# Village of Arlington Heights Building & Life Safety Department

**To:** Sam Hubbard, Development Planner, Planning and Community Development  
**From:** Deb Pierce, Plan Reviewer, Building & Life Safety Department  
**Subject:** Sigwalt 16 – PUD, Rezoning to R-7, Plat of Subdivision, Variations  
**PC#:** 19-005 – Round 1  
**Date:** April 25, 2019

To: Sam Hubbard, Planning & Community Development  
From: Cris Papierniak, Assistant Director of Public Works  
Date: May 1, 2019  
Subject: 45 S Chestnut Ave (16 Sigwalt) P.C. #19-005

**PLAN COMMISSION PC #19-005**  
**Sigwalt 16**  
**45 S Chestnut Ave**  
**PUD, Rezoning to R-7, Plat of Subdivision, Variations**  
**Round 1**

DETAIL B

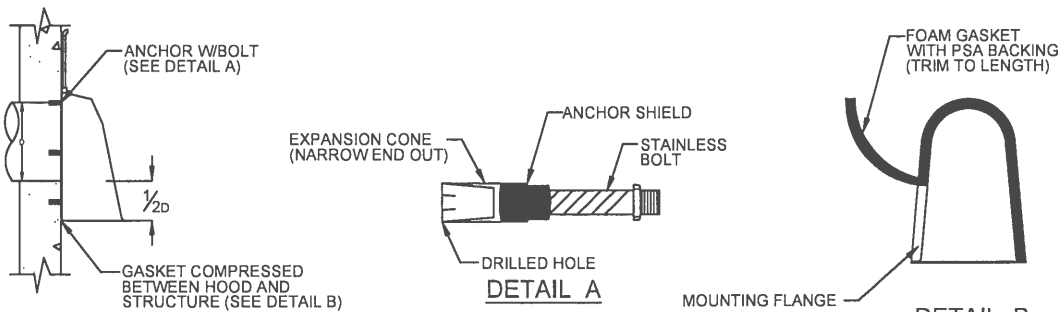
- b) If the detention storage system will be located under pavement, it must be designed to AASHTO HS-25 loading standard.
  - c) The outlet pipe in the special restrictor structure must have a trap with a removable hood. For reference is a removal hood detail from the Metropolitan Water Reclamation District.
